ENCLOSURE 2

NRC DOCKETS 50-321, 50-366  
OPERATING LICENSES DPR-57, NPF-5  
EDWIN I. HATCH NUCLEAR PLANT UNITS 1, 2  
REQUEST TO AMEND TECHNICAL SPECIFICATIONS-TMI ACTION PLAN ITEMS

The proposed changes to Unit 1 Technical Specifications (Appendix A to Operating License DPR-57) would be incorporated as follows:

# WATER LEVEL NOMENCLATURE

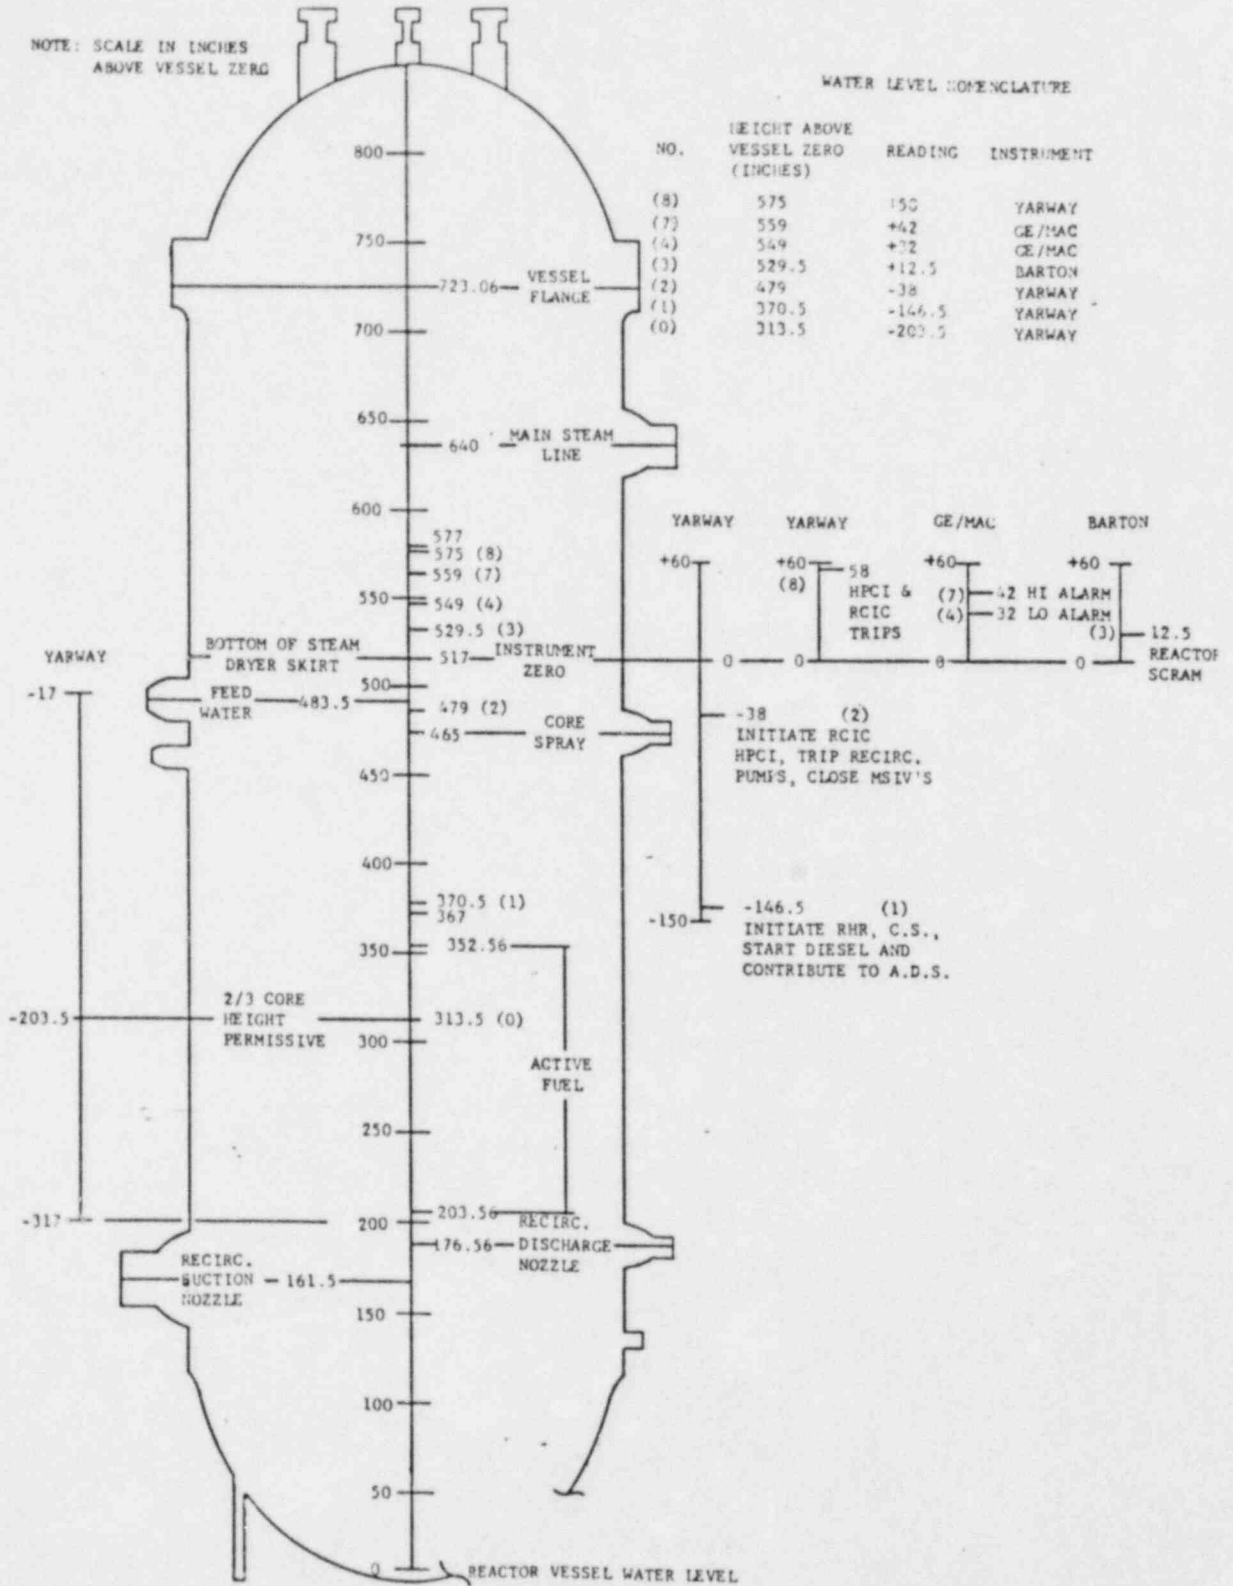
<u>Remove Page</u>	<u>Insert Page</u>
Figure 2.1-1	Figure 2.1-1
3.2-9	3.2-9
	3.2-9A
3.2-22	3.2-22
	3.2-22A
3.2-23	3.2-23
	3.2-23A
3.2-31	3.2-31
	3.2-48A
3.2-49	3.2-49
3.2-57	3.2-57
3.2-68	3.2-68
3.5-7	3.5-7
3.5-8	3.5-8
3.5-17	3.5-17
	6-1A
6-15	6-15
6-17	6-17
